MEMORANDUM

To: The Design Advisory Board
From: Mary O'Neil, AICP, Principal Planner
RE: ZP21-509 72-76 Elmwood Avenue
Date: November 23, 2021

File: 21-509
Location: 72-76 Elmwood Avenue
Zone: RM **Ward:** 2C
Parking District: Neighborhood
Date application accepted: June 24, 2021
Request to defer for redesign and survey: July 23, 2021
Revised plans received: October 26, 2021, November 15, 2021.
First DAB Review: November 9, 2021
Applicant/ Owner: Michael Alvanos / PBGC LLC (Bill Bissonette)
Request: Build three unit detached residential structure on the site of the former Free Methodist Church. One existing single family residence remains on site. (Planned Unit Development)

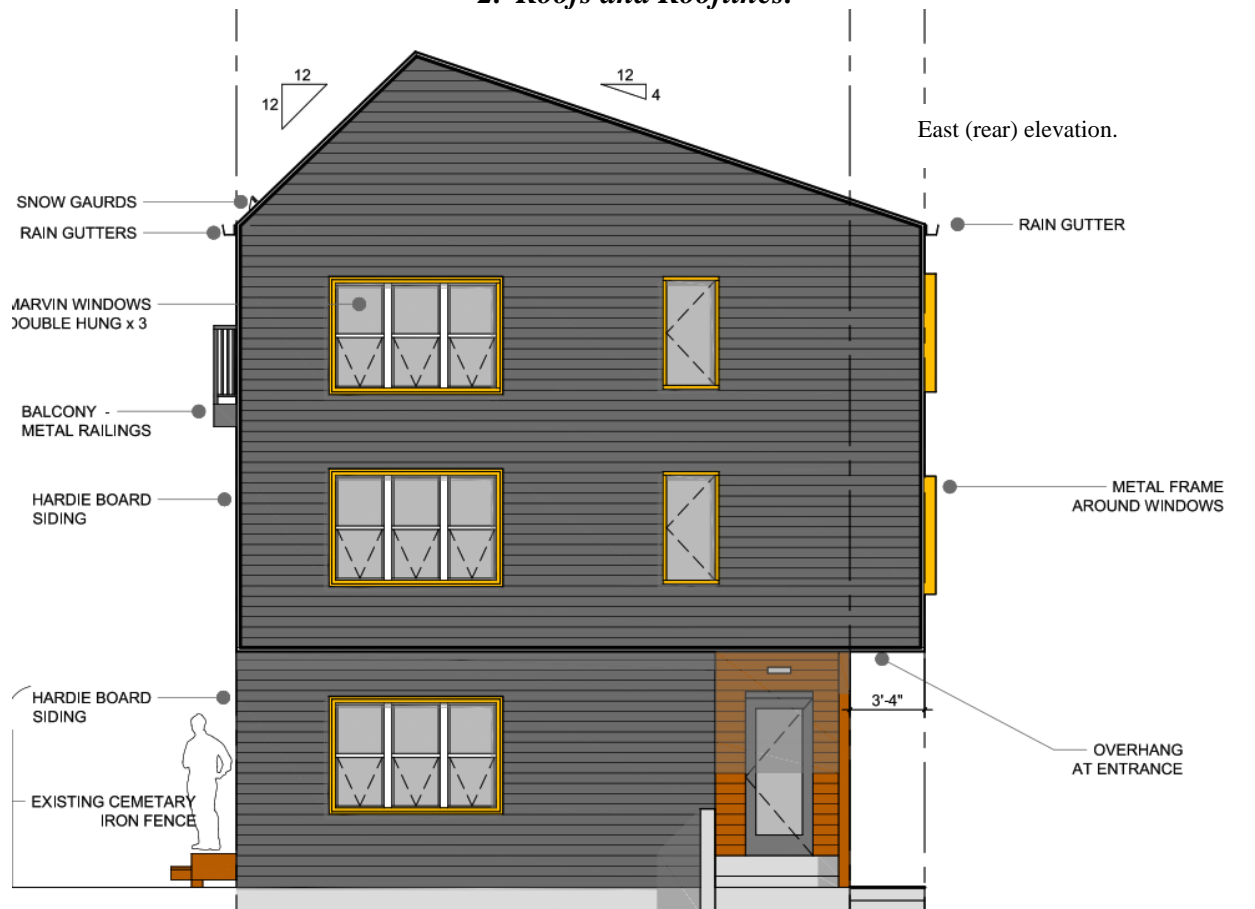
1. Massing, Height and Scale:

72-76 Elmwood Avenue has only one abutting neighbor; 68 Elmwood Avenue. It is a gable-and-eaves front 2 ½ story residential building. Across the street on the corner of Peru Street is a modified Dutch Colonial, and the much grander St. Joseph's rectory.

Although presenting eaves-front to the street, the height and massing of the proposed building is consistent with other structures in the immediate area.

2. Roofs and Rooflines.

The proposed building has a modified cat-slide roof with dual pitch and zero eave extrusion. Responding to DAB comments, snow guards and rain gutters have been added on the north and south elevations. In style it reads as a modern infill.

3. Building Openings

Fenestration is a mix of triple and double ganged windows and single casements. Sliding doors are noted on the north elevation first floor and third floors.

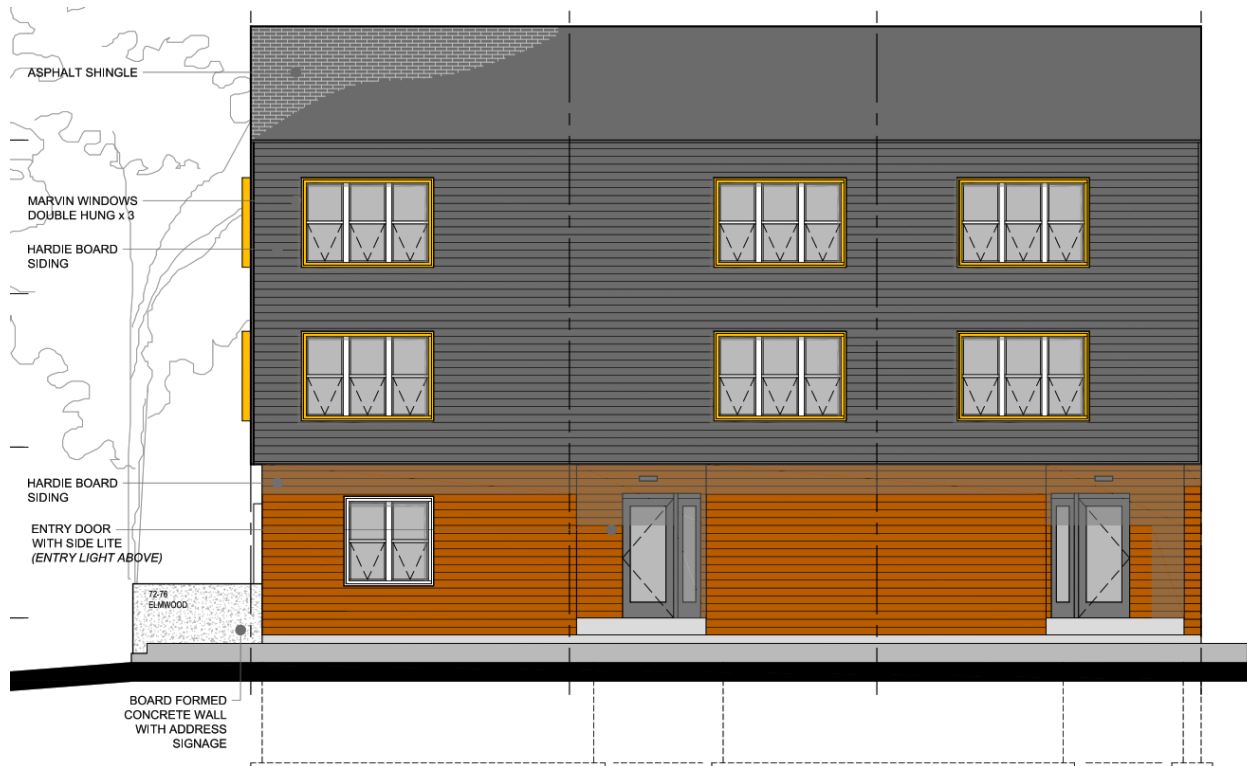
As designed, the building lacks typical façade articulation such as bays, horizontal and vertical façade articulation, porches, patios, articulated bases, step-backs or other street level details. Windows are stacked, however, providing a measure of arrangement. The plan is modernistic with a simplified form and little detailing. The only interest provided is the angular and asymmetrical roof line, and “framed” window surrounds. Revisions include a differentiated first floor south and west entry, as requested by the Design Advisory Board.
